FACILITIES PROGRAM UPDATE
SOUTHWEST APPLIED TECHNOLOGY COLLEGE
CEDAR CITY, UTAH
UTAH COLLEGE OF APPLIED TECHNOLOGY

PROGRAM
SUPPLEMENT
#1

JUNE 26, 2014

Frank N Murdock Jr Architect & Associates
975 East 100 South, Salt Lake City, Utah 84102

Revised
Page 295

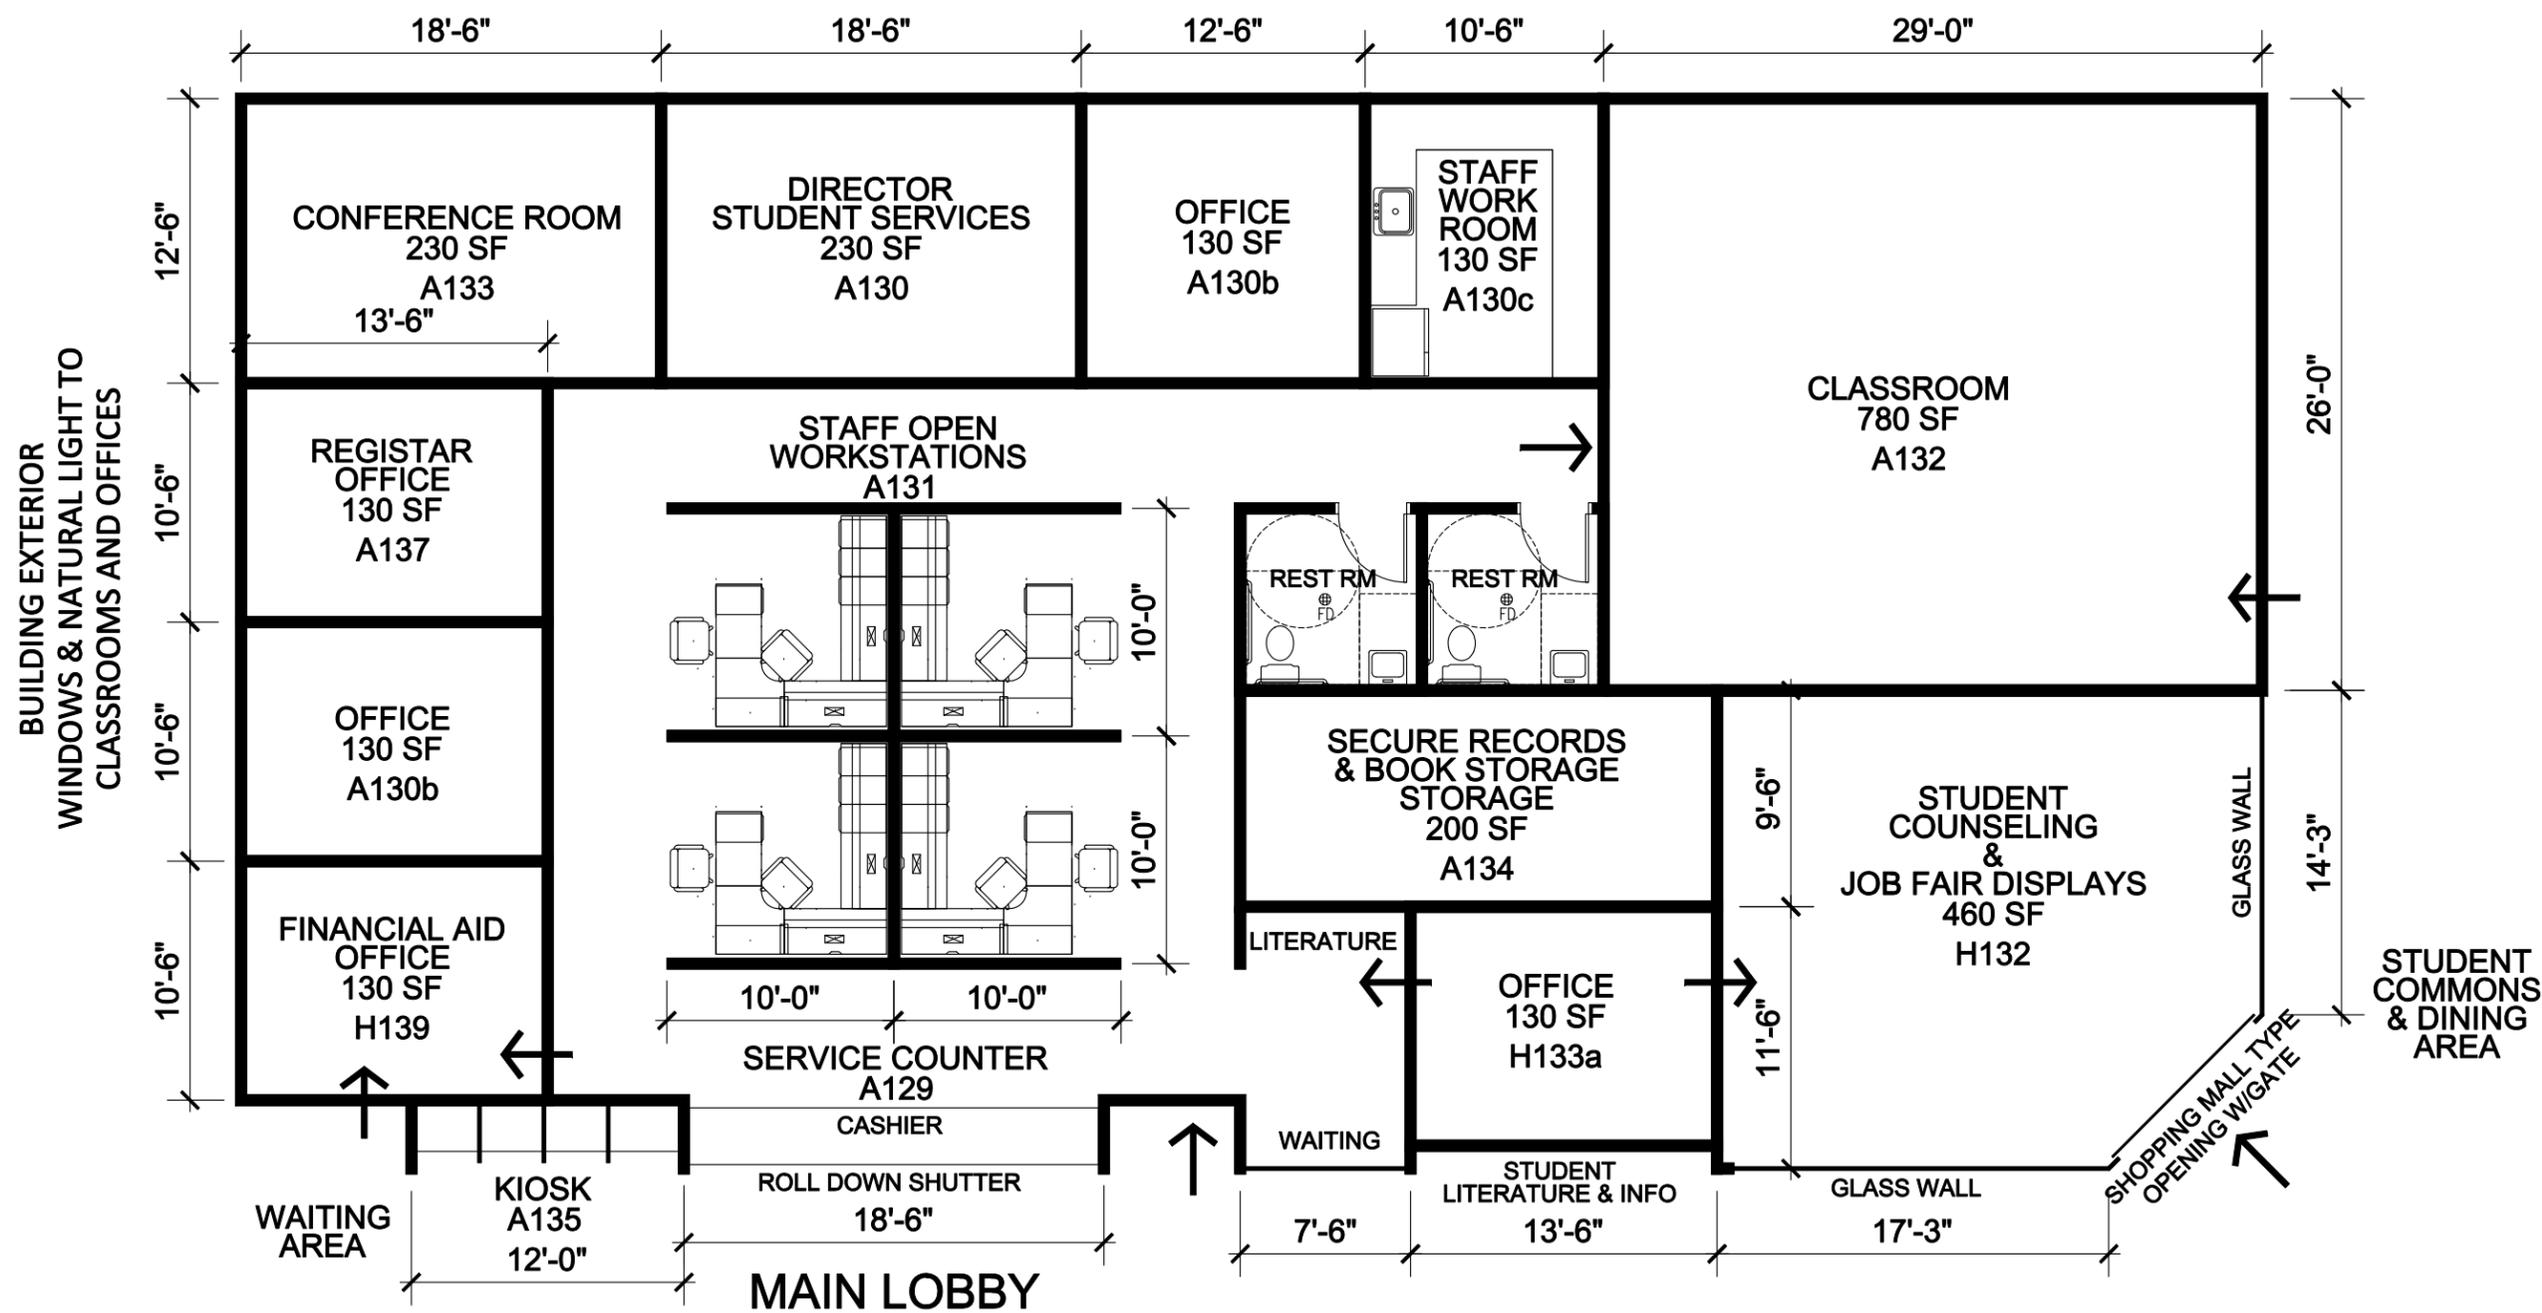
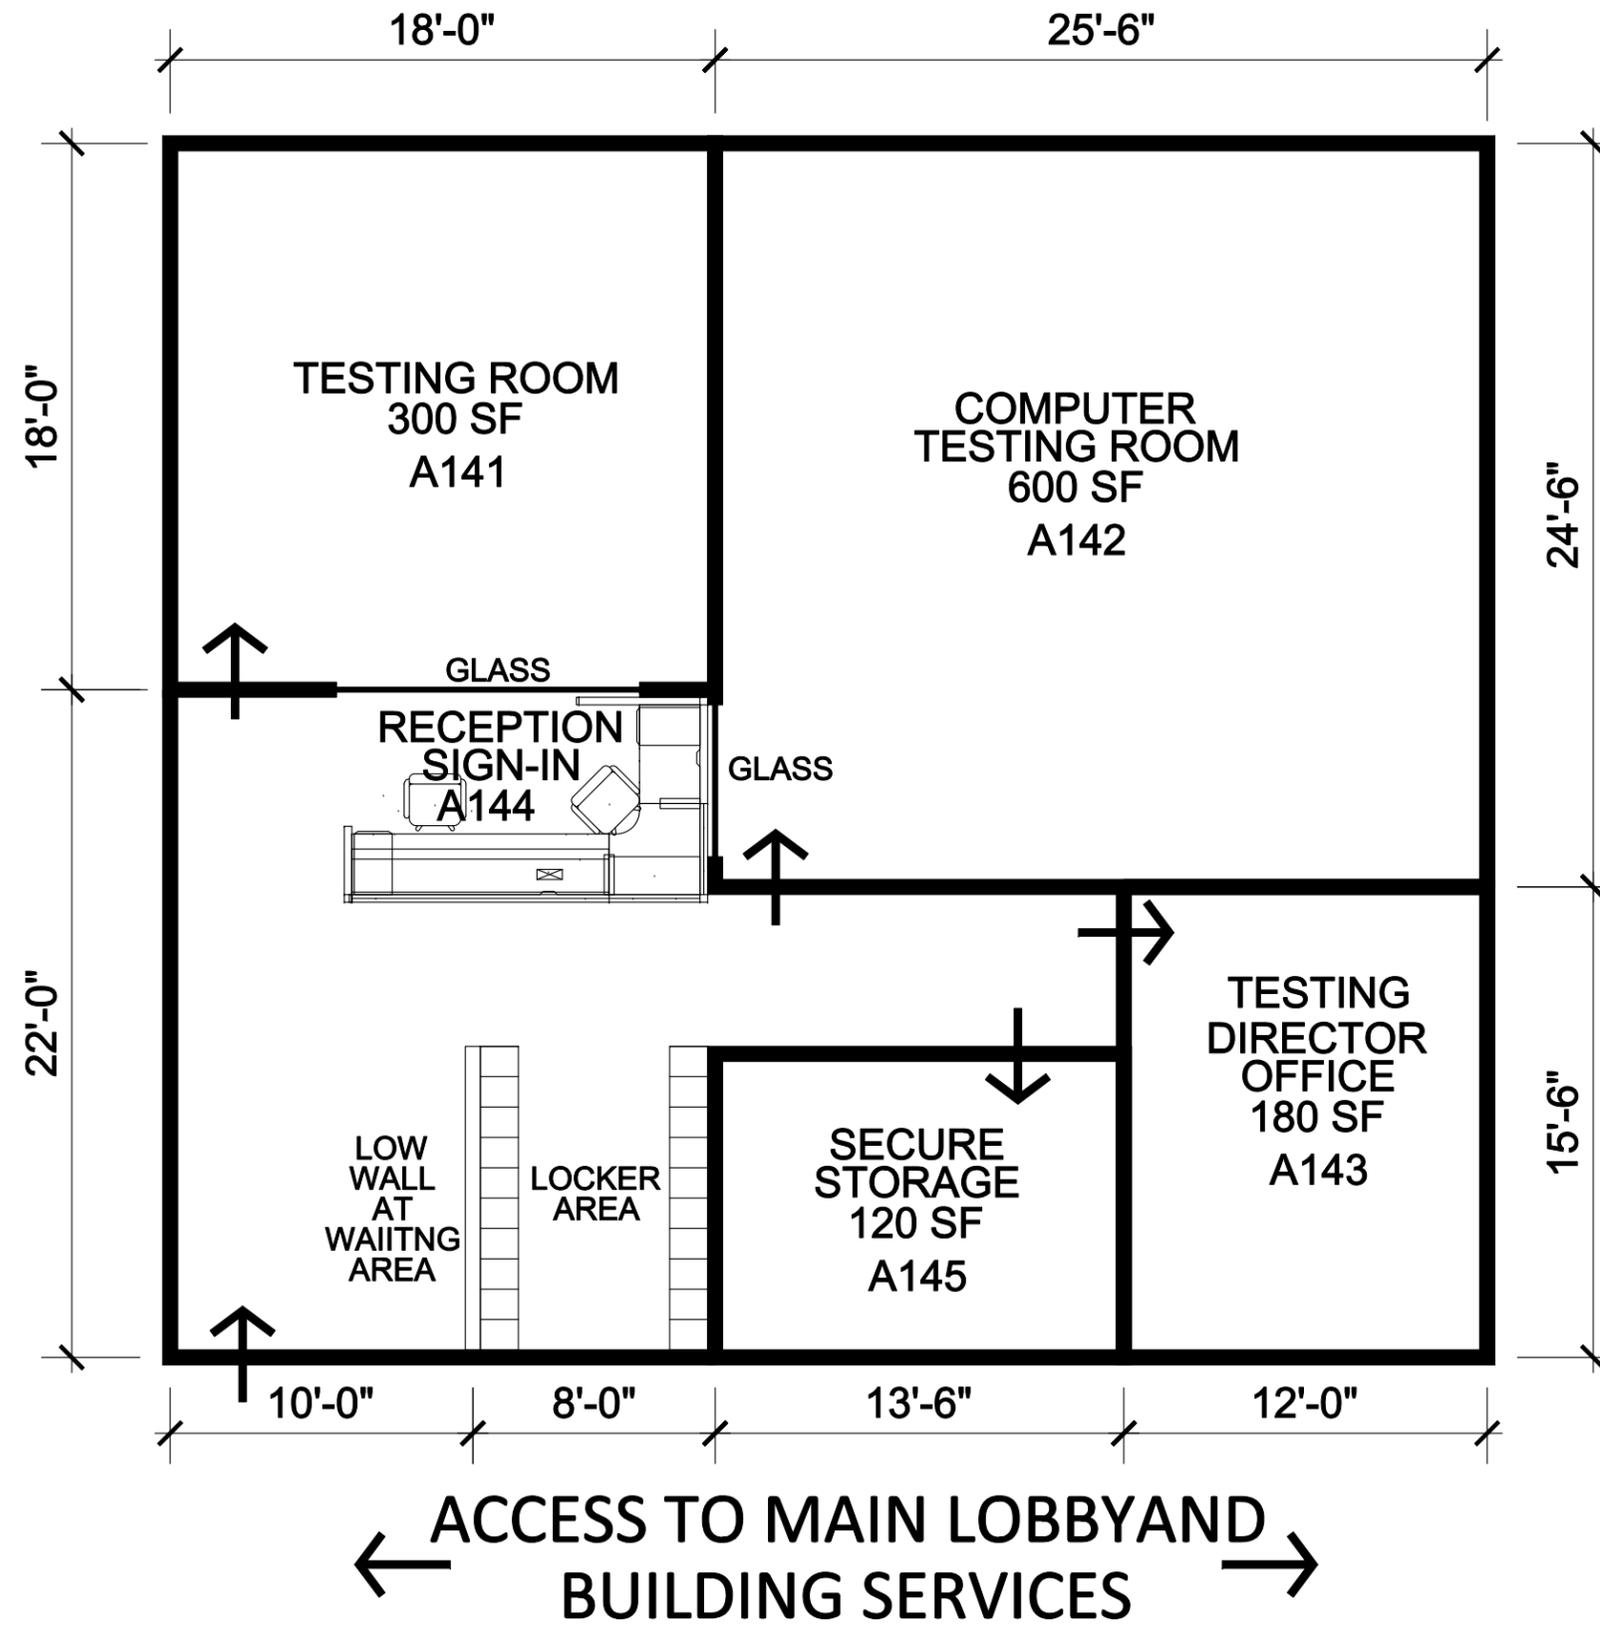
80. Page 295: Adjacency Diagrams: Student Services Adjacency Diagram: Delete page 295 and replace with Attachments, Revised Page 295 Student Services Adjacency Diagram.

81. Page 302: Classroom A132: Revise as indicated on the Attachments, Revised Page 295 Student Services Adjacency Diagram.
82. Page 310-317: Casework & Fixed Equipment: Move all cabinetry items to Moveable Furnishings.

Revised
Page 319
Testing

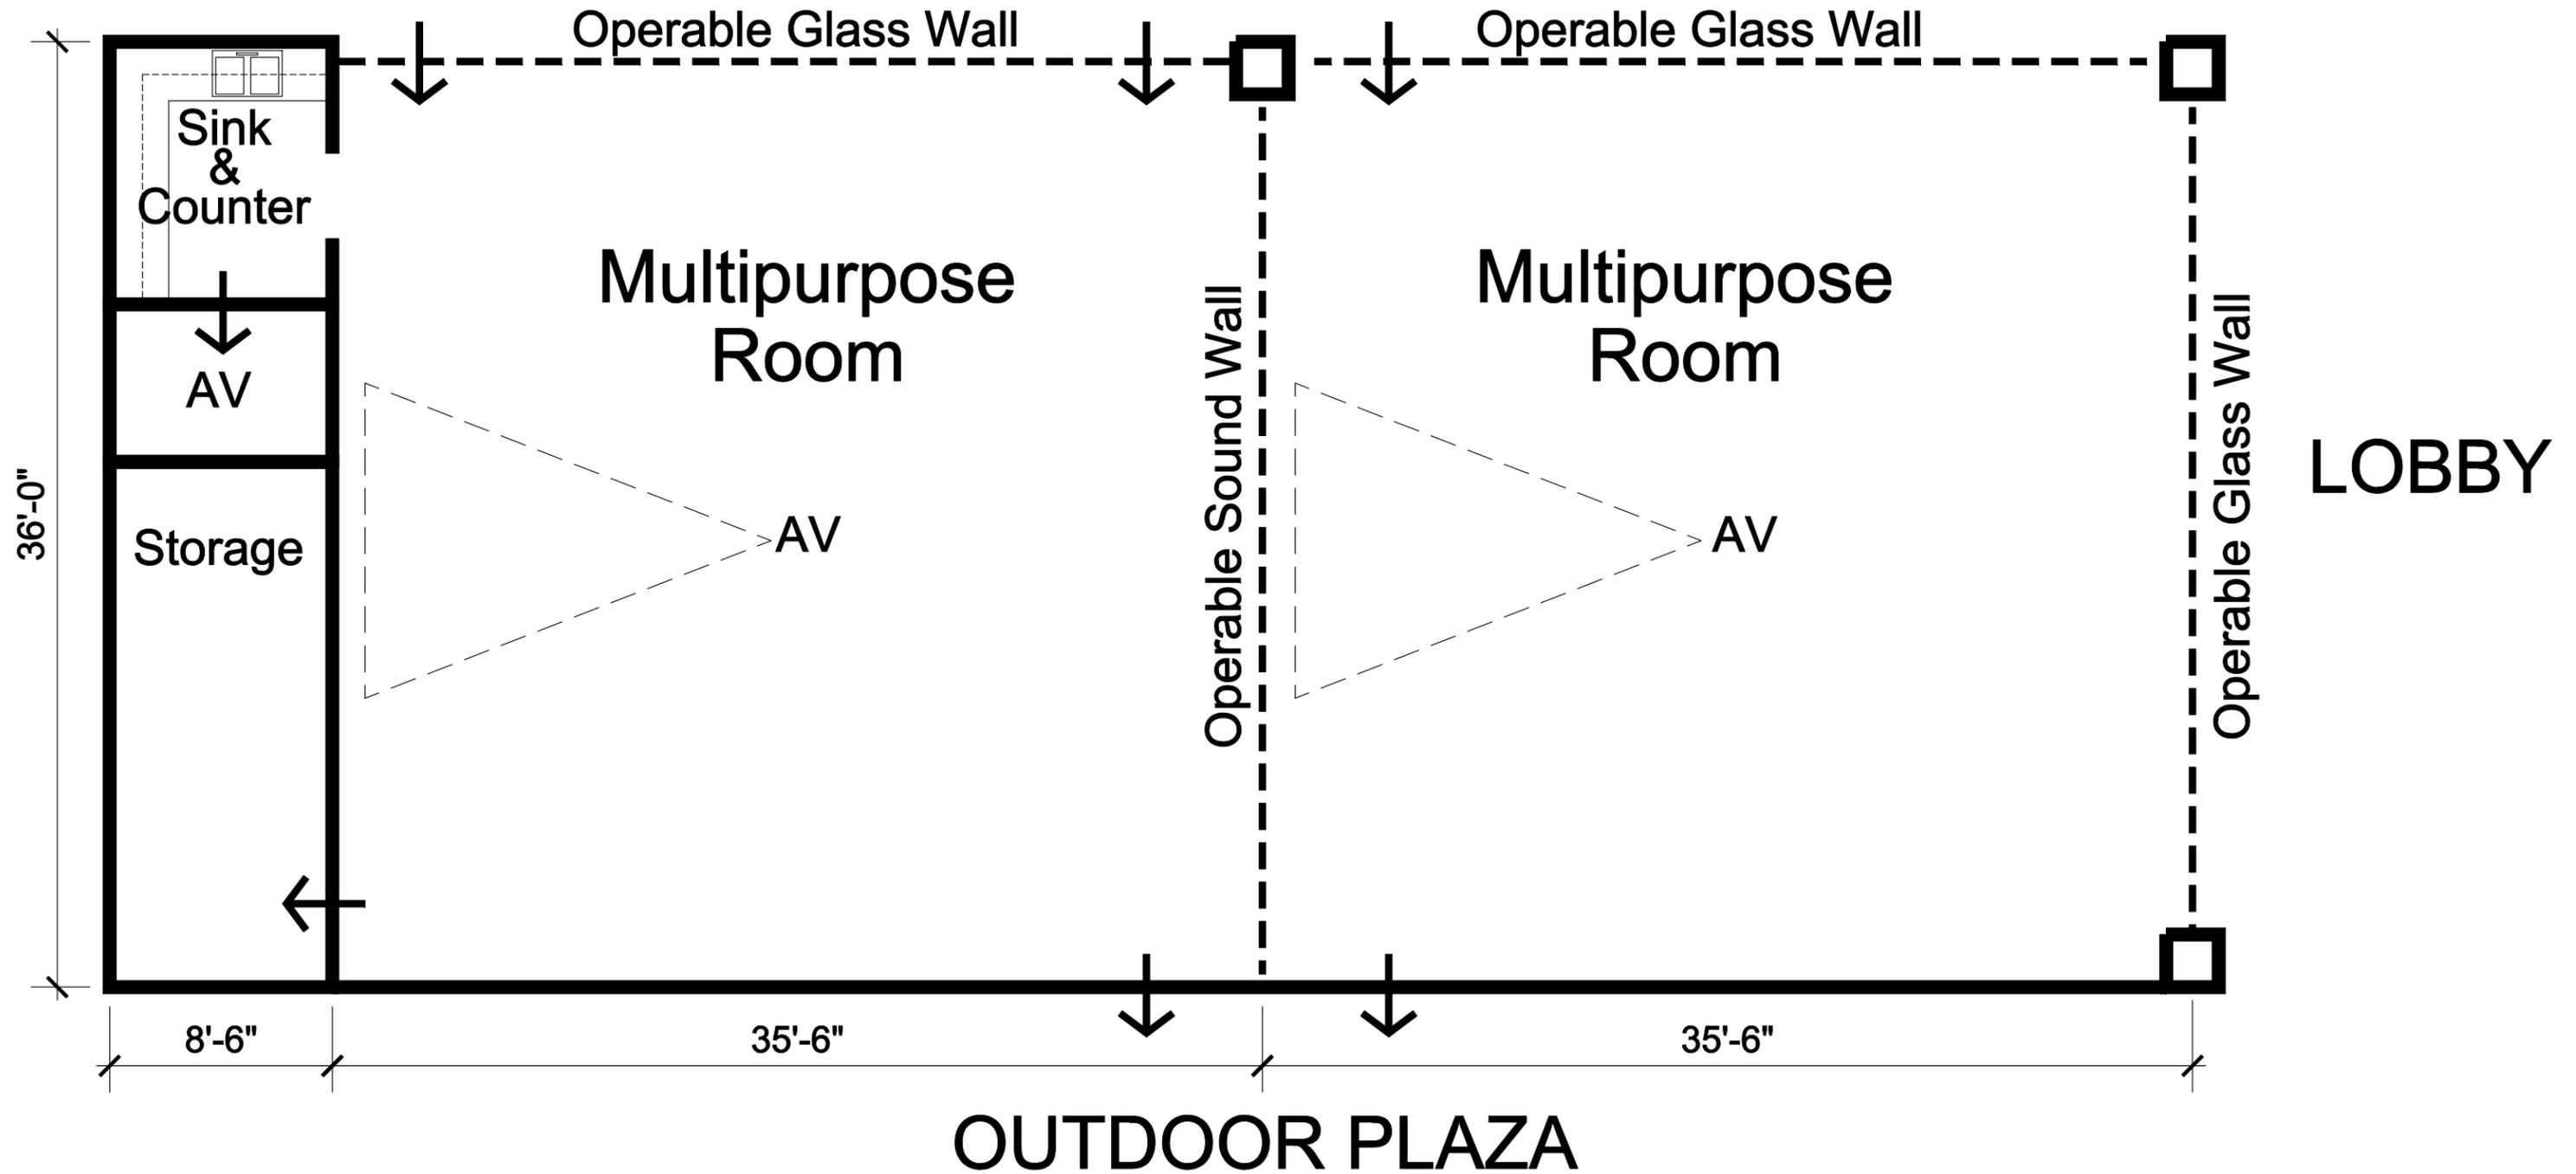
84. Page 319: Adjacency Diagrams: Testing Center Adjacency Diagram: Delete page 319 and replace with Attachments, Revised Page 319 Testing Center Adjacency Diagram.
